AGENDA FOR REGULAR MEETING VILLAGE OF TINLEY PARK PLAN COMMISSION

**ITEM #1 PUBLIC HEARING – DUNKIN’ DONUTS OUTLOT REDVELOPMENT
(TINLEY DOWNS PLAZA) – SPECIAL USE FOR PUD AND SITE
PLAN/ARCHITECTUAL APPROVAL**

PLAN COMMISSION STAFF REPORT

- Special Use for a PUD
- Site Plan &
Architectural Approval

A.1.1

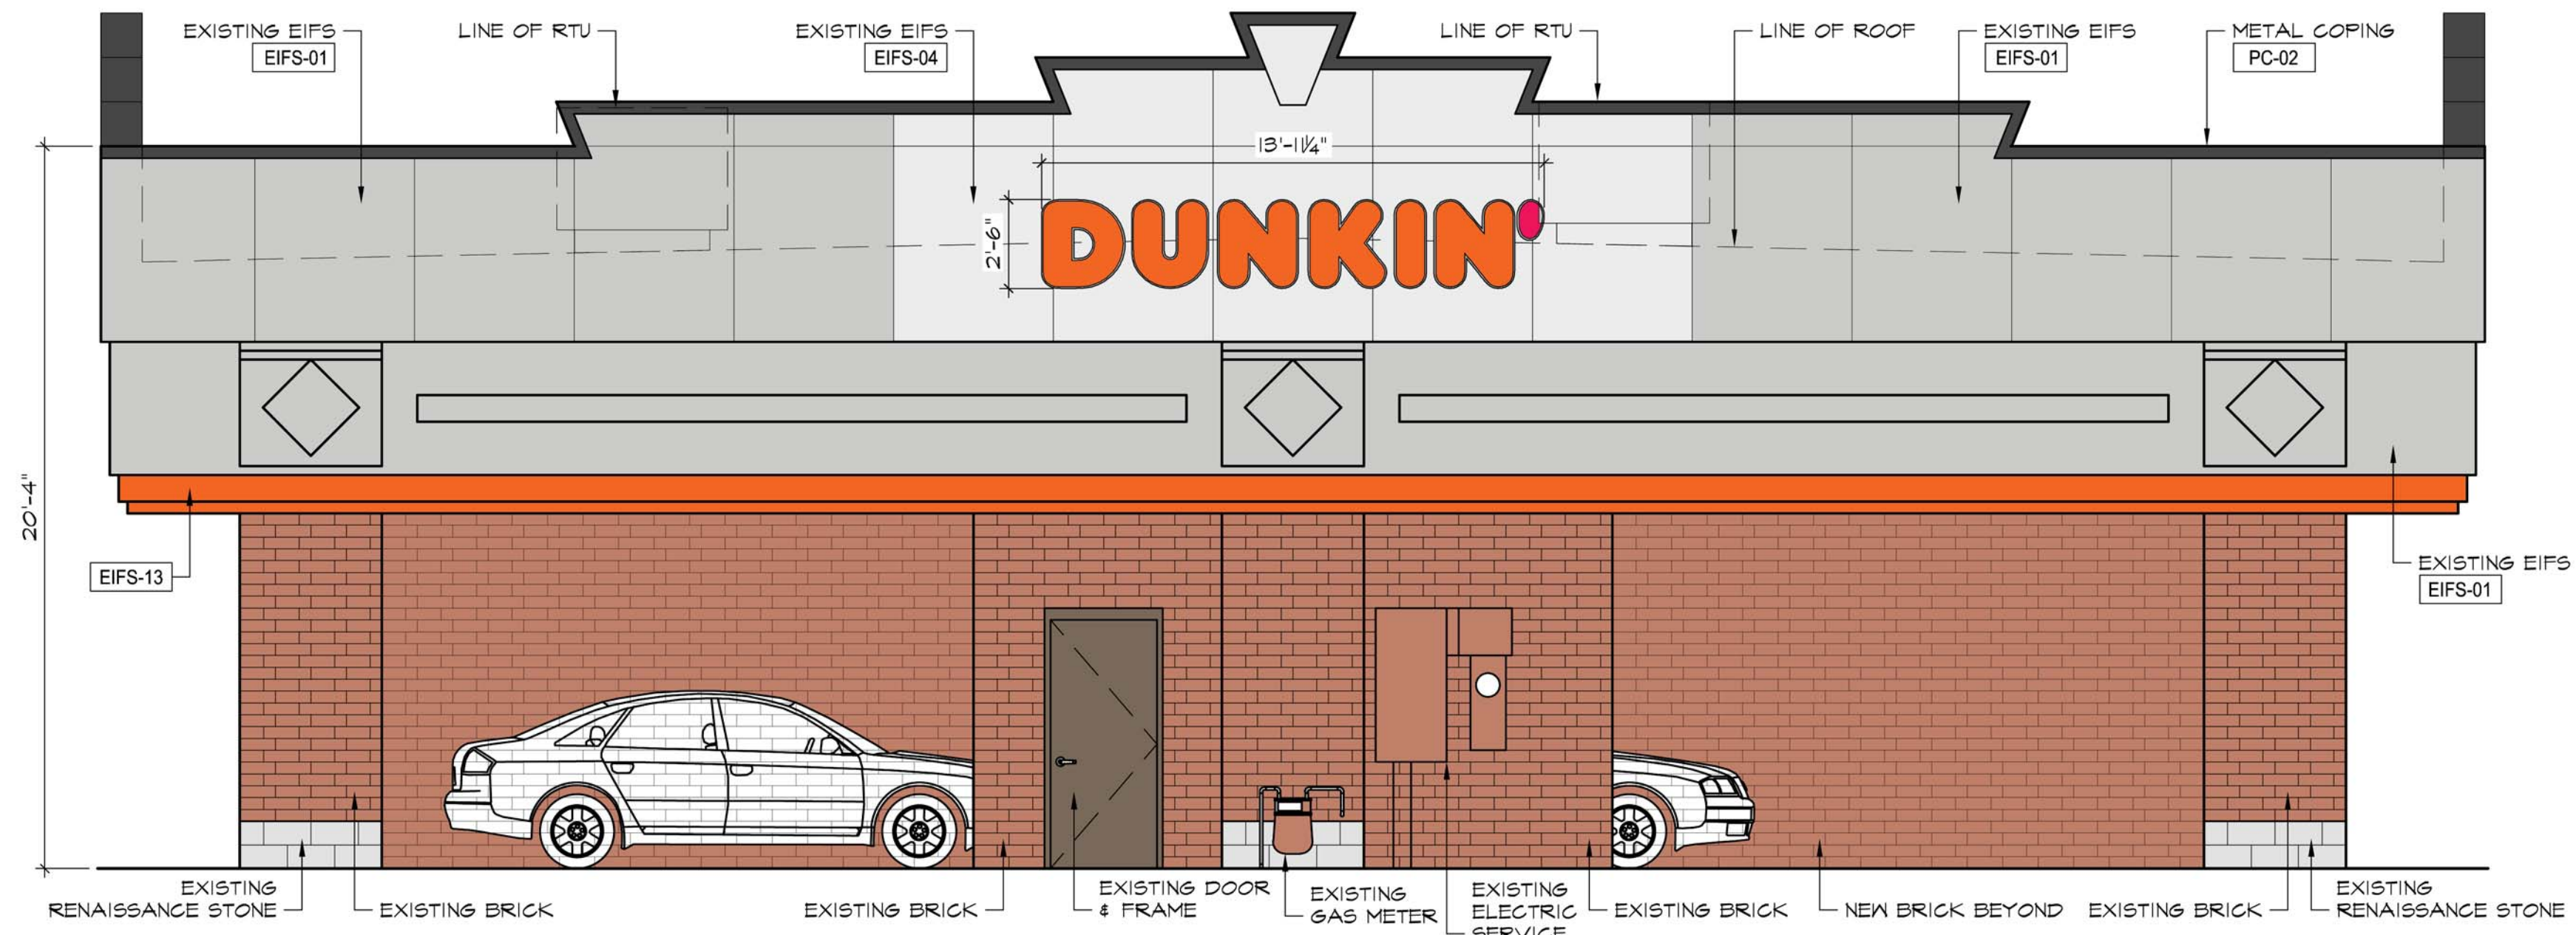
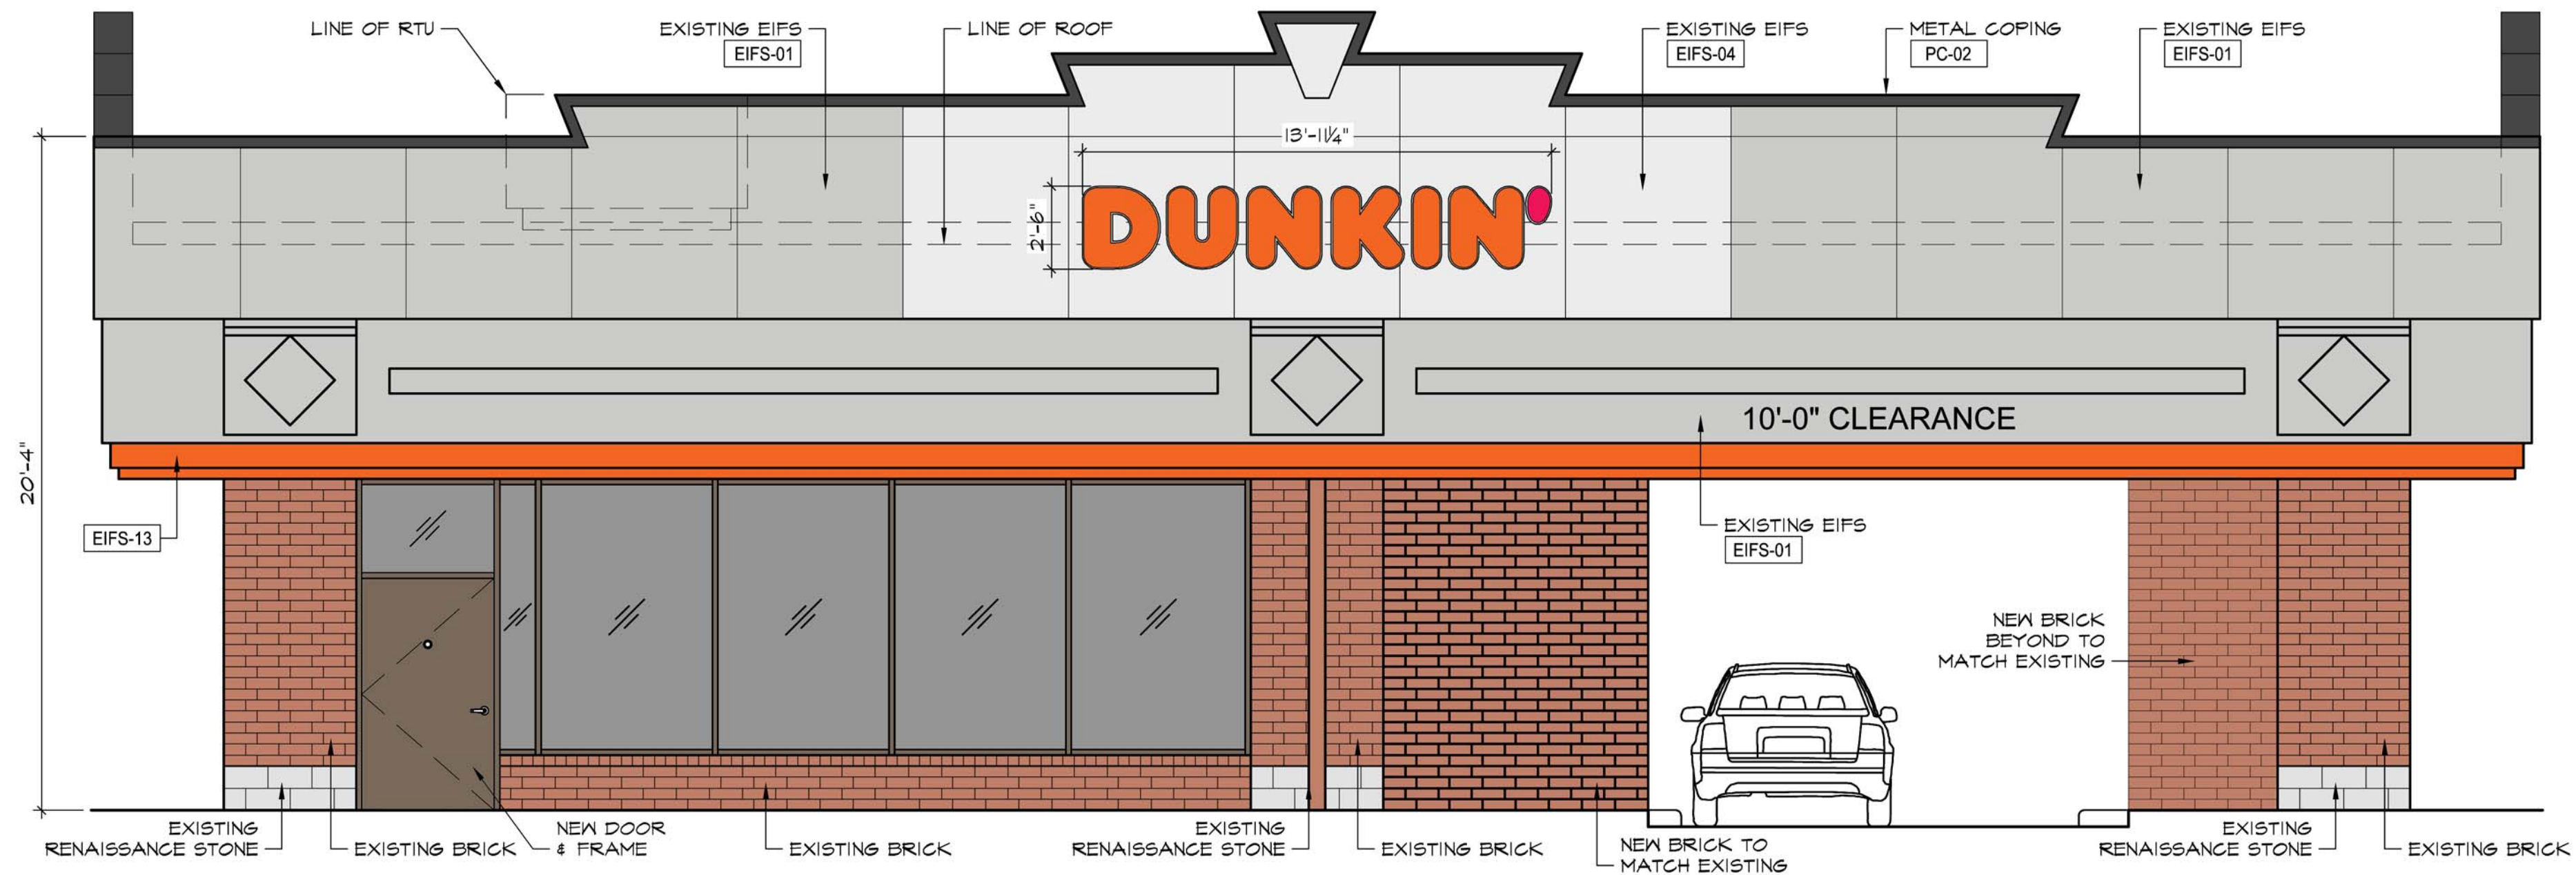
COMMISSIONER MANI noted the plan looks good. He noted one of the elevations has two doors. He asked if those doors are functional. He suggested a railing be added.

The Petitioner revised plans and clarified the addition of a new door on the north side elevation. The also clarified removing the existing doors on the east elevation. The rear door is proposed to be a solid metal door and staff would recommend this be a glazed door to match the rest of the exterior façade windows along the façade. This will be a highly visible façade along 171st Street frontage. The windows can be tinted or covered to decrease visibility into the backroom area. Current windows have a mirrored tinting that can be used so that the façade has a matching exterior.
